Access Compliance Report

Public Rights-of-Way

(Curb Ramps)

Intersection ID: 10020180	Main Street: AUBURN_AV	Cross Street: N/A	Location: E
ADA ID: 96C61C6A701E	Ramp Type: PerpDiag	Initial Pass/Fail: Fail	Overall Compliance: No
Codes/Mitigation Info/Possible Solution		Field Measurements/Component Compliance	
Severity Score: 46.25

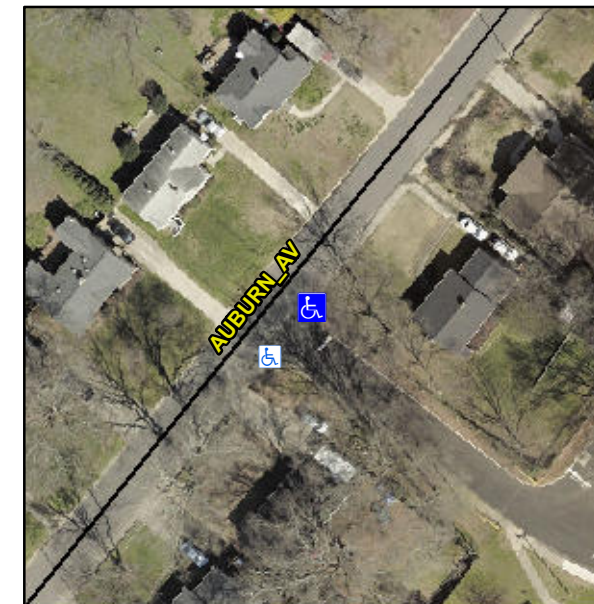
Not Found, R304.5.1, R304.2.2, R304.5.3

Compliance	Description	Data	Compliance	Description	Data
N/A	Ramp Length (in)	32.0	No	Ramp Slope (%)	15.7
No	Ramp Width (in)	44.0	No	Ramp XSlope (%)	5.6
N/A	Flare Type LT	N/A	N/A	Flare Type RT	N/A
N/A	Flare Slope LT (%)	N/A	N/A	Flare Slope RT (%)	N/A
N/A	Flare Traversable LT?	N/A	N/A	Flare Traversable RT?	N/A
N/A	Landing Length (in)	N/A	N/A	DWS Provided?	N/A
N/A	Landing Width (in)	N/A	N/A	DWS Contrast?	N/A
N/A	Landing Slope (%)	N/A	N/A	DWS Length (in)	N/A
N/A	Landing X Slope (%)	N/A	N/A	DWS Full Width?	N/A
N/A	Landing Curb? (Y/N)	N/A	N/A	DWS Offset (in)	N/A
N/A	Shared Landing?	N/A			
N/A	Gutter Ponding?	N/A	N/A	Gutter Slope (%)	N/A
N/A	Gutter Lip Ht (in)	N/A	N/A	Gutter X Slope (%)	N/A
N/A	Painted X Walk1?	No	N/A	Painted X Walk2?	No
	X Walk 1 Direction	To NW		X Walk 2 Direction	To SW
N/A	X Walk 1 Width (in)	N/A	N/A	X Walk 2 Width (in)	N/A
	X Walk 1 Slope (%)	5.2		X Walk 2 Slope (%)	0.3
	X Walk 1 X Slope (%)	1.3		X Walk 2 X Slope (%)	5.6

Remove & Replace Curb Ramp With Two New Directional Ramps or Equivalent.
